ROSEBURG URBAN SANITARY AUTHORITY

**Addendum #1
to
Request for Proposals for
Wastewater Collection System Master Plan Amendment**

Exhibit A to Addendum #1

Questions & Answers

LOMA VISTA LIFT STATION PRELIMINARY LAYOUT

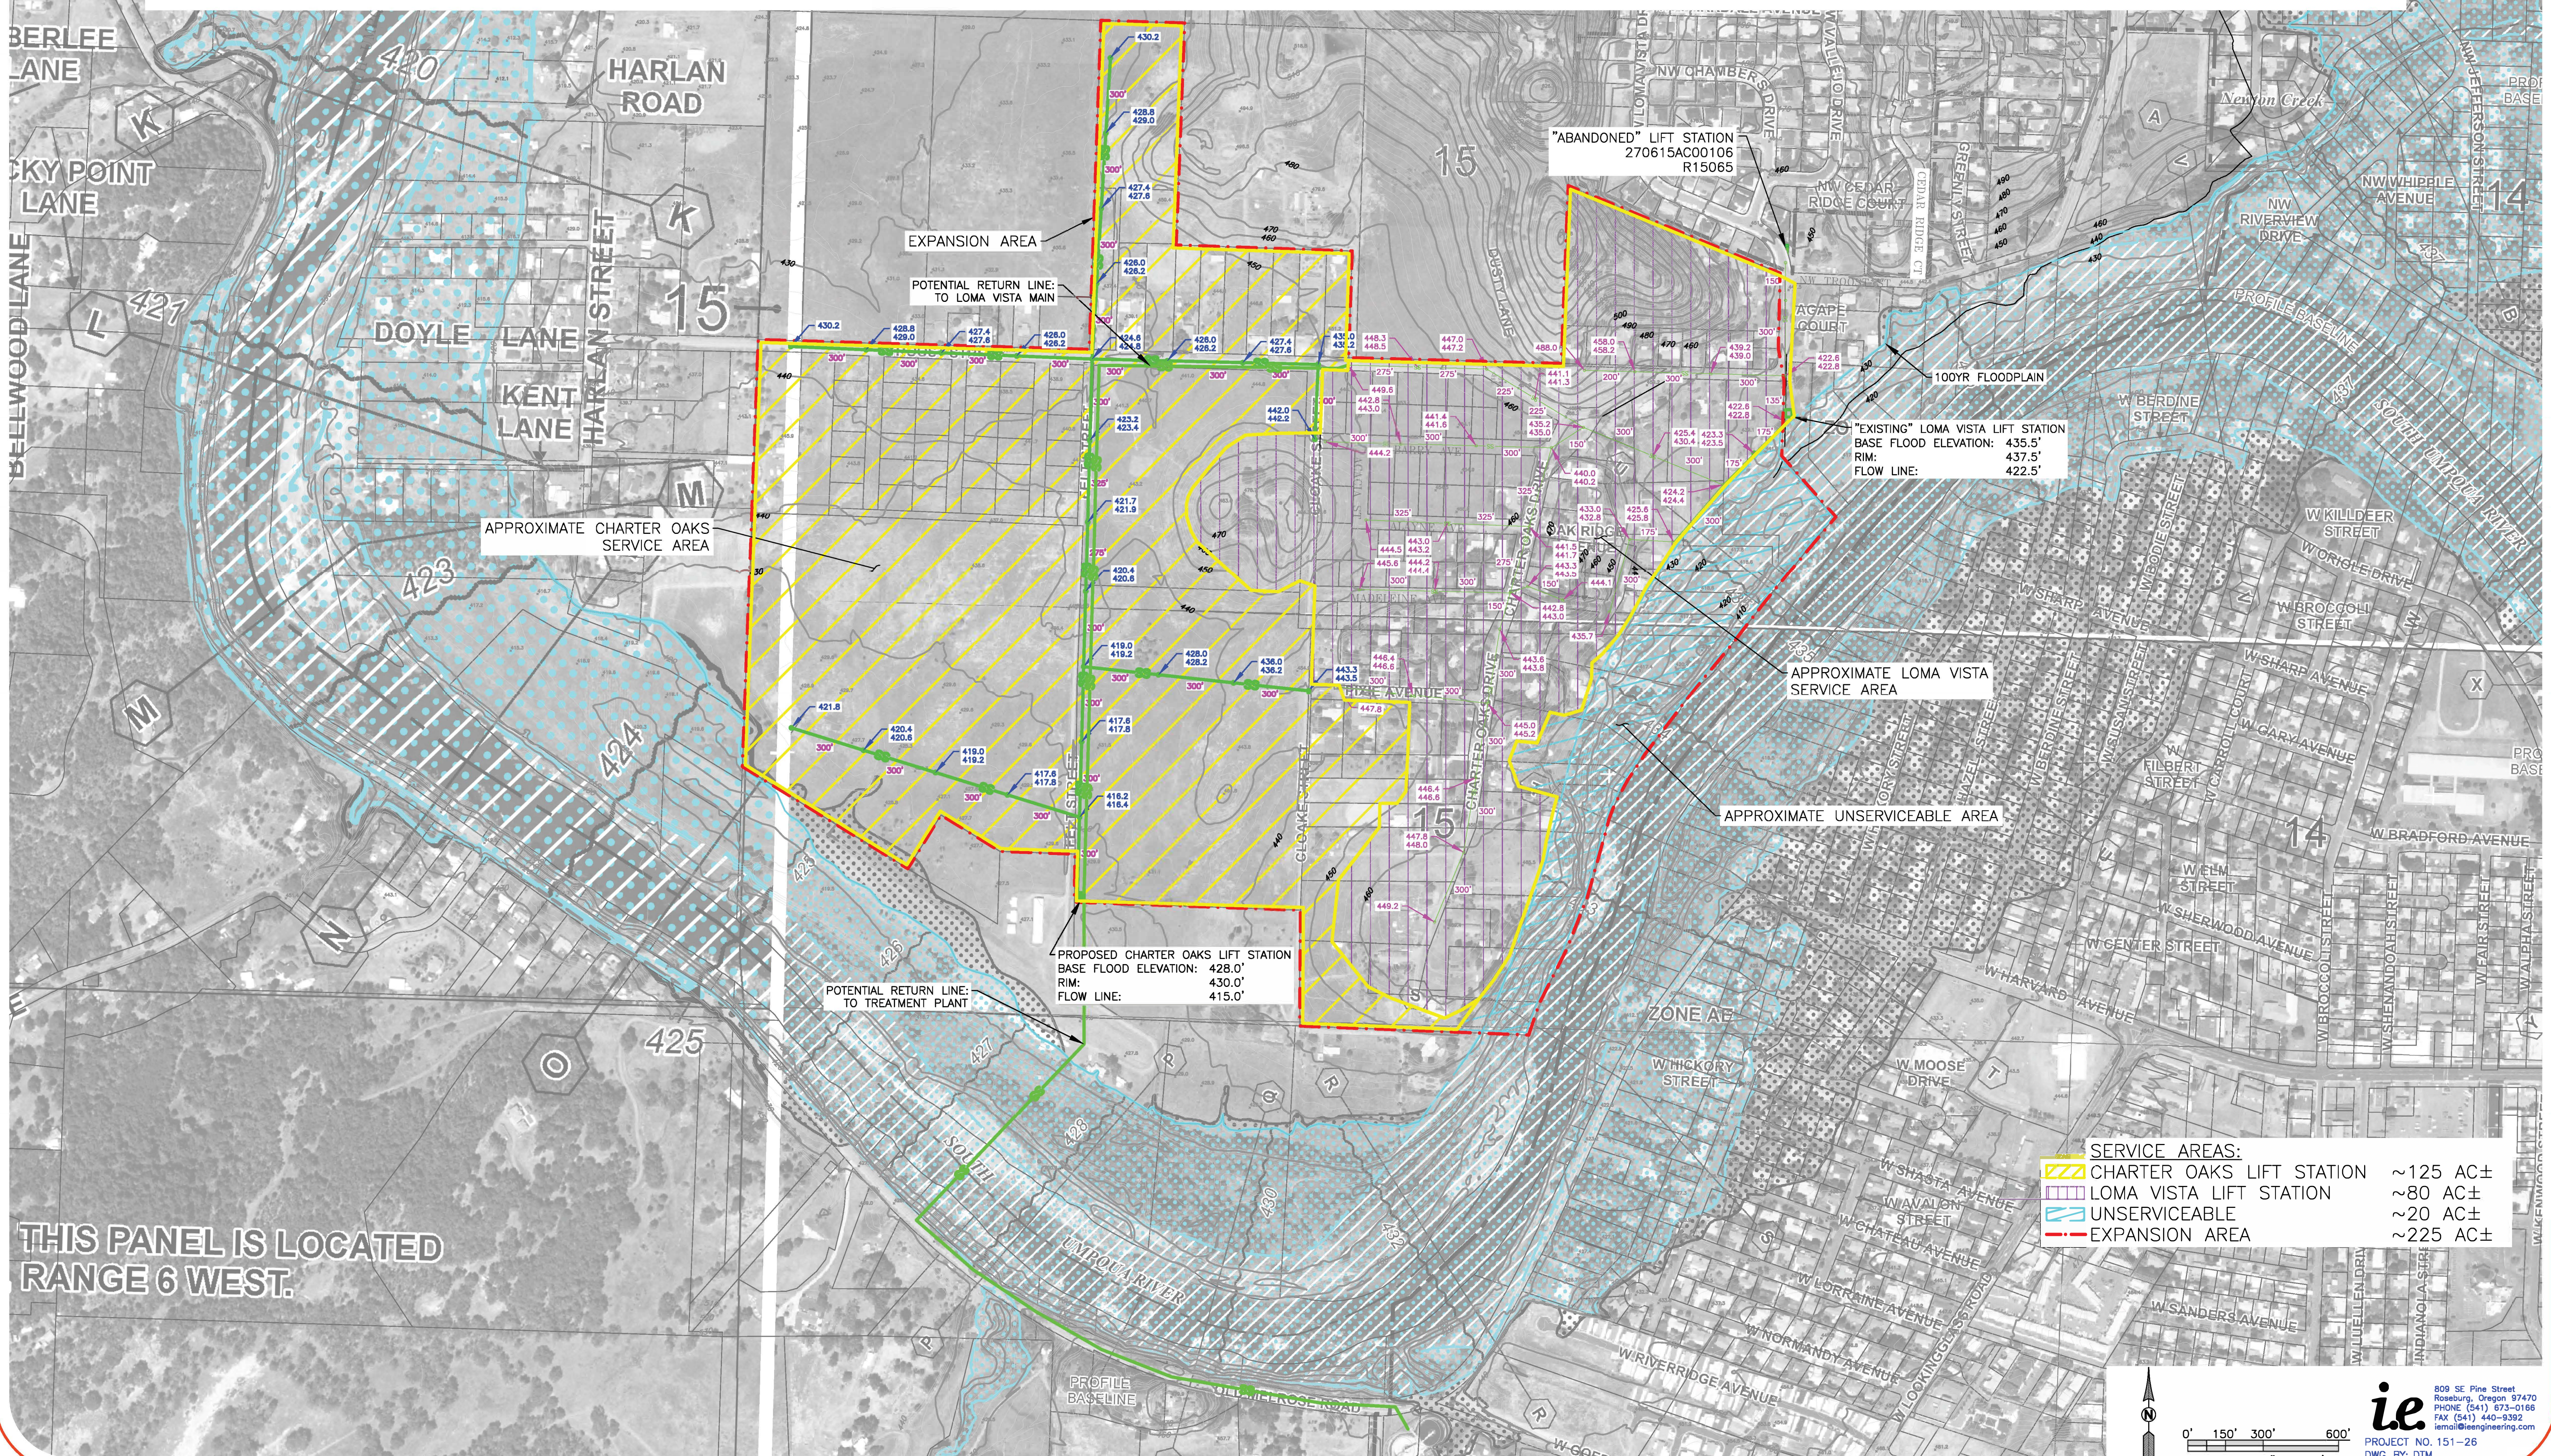
1.5	Is additional information available regarding the service area for the Loma Vista Pump Station?	Attached are the following reference documents: <ul style="list-style-type: none">• Loma Vista Lift Station Preliminary Layout, dated 2018-11-08• Loma Vista Trace as of 1-28-25 (lines shown in cyan drain to the Loma Vista Pump Station)
